**PLANNING BOARD AGENDA
NOTICE OF MEETING**

TITLE: Special Planning Board Meeting FILE: PLAN-2019-23-August-6a-1 Traffic Study Maypoint Road / Capital Drive OWNER: Cordova Realty		
MEETING DATE: August 23, 2019		Page 1 of 4
DEPARTMENT: Planning & Heritage	ATTACHMENTS: A. Property Map B. 2019 Traffic Study prepared by EXP Services Inc. C. Site Plan TIE Comments D. Departmental Comments	
SITE INFORMATION: Context: Proposed Tim Horton’s Drive Thru queuing and stacking plan Ward No: 7 Existing Land Use: Hotel and foundation for proposed drive thru restaurant, convenience store, quick service restaurant and gas bar (8 pumps), and separate car wash. Official Plan: Commercial Zoning: C 2 Highway Commercial		
PREVIOUS APPLICATIONS: 2016 Rezoning Application

Update of the Traffic Impact Study for a Development on Capital Drive Charlottetown, PEI

DDT OPTION 3

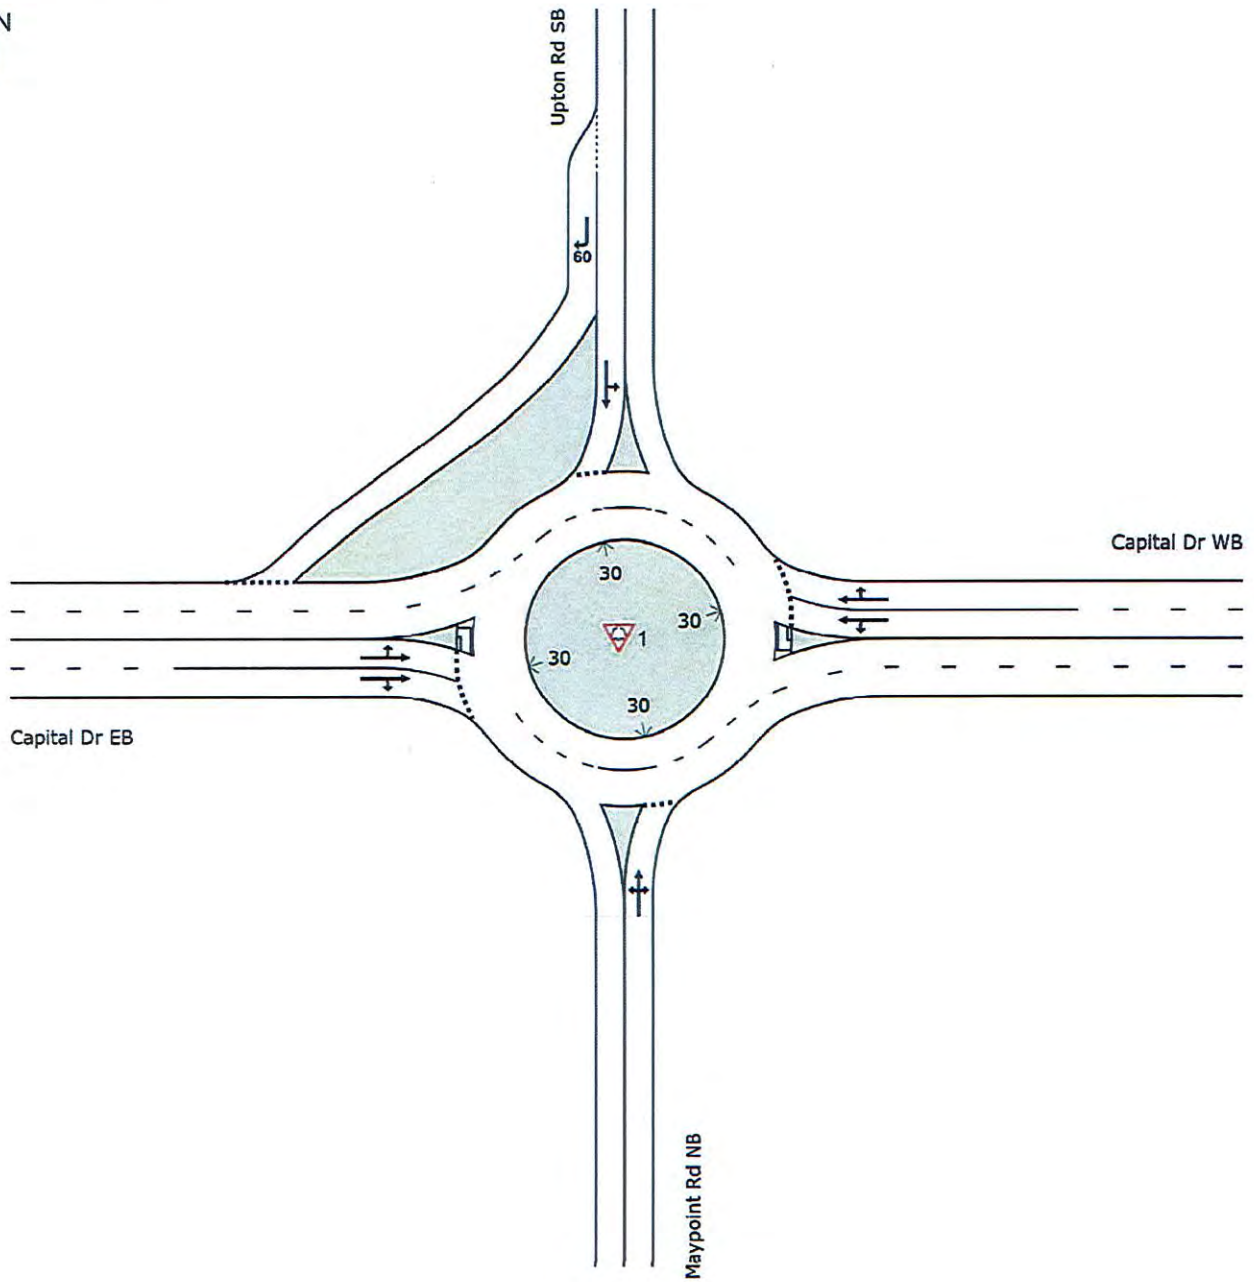
The attached report provides the required analysis of the implications and impacts from the proposed two lane queuing aisles for the Tim Horton's restaurant. Additional comments from the Province and input from the relevant City departments (Police and Public Works) to determine stacking requirements can be found as follows:

The proposed Tim Horton queuing lanes would have approximately 108m of queuing in the lineup and over 70m of queuing towards Maypoint and the gas pumps. The proposed development would therefore provide more queuing space than the other five above mentioned developments.

This new TH would have about 108m of queuing in the line up and over 70m of queuing towards Maypoint and the gas pumps. This site would thus seem to provide more queuing space than the other 5 above noted TH's.

The Planning & Heritage Department recommends that Planning Board recommend to Council to approve the request to accept the traffic study prepared for the development on the corner of Maypoint Road and Capital Drive (PID 387365) to permit a drive thru Tim Horton’s restaurant (stacking and queuing spaces) as proposed in the traffic study in Appendix “A” Option 3.
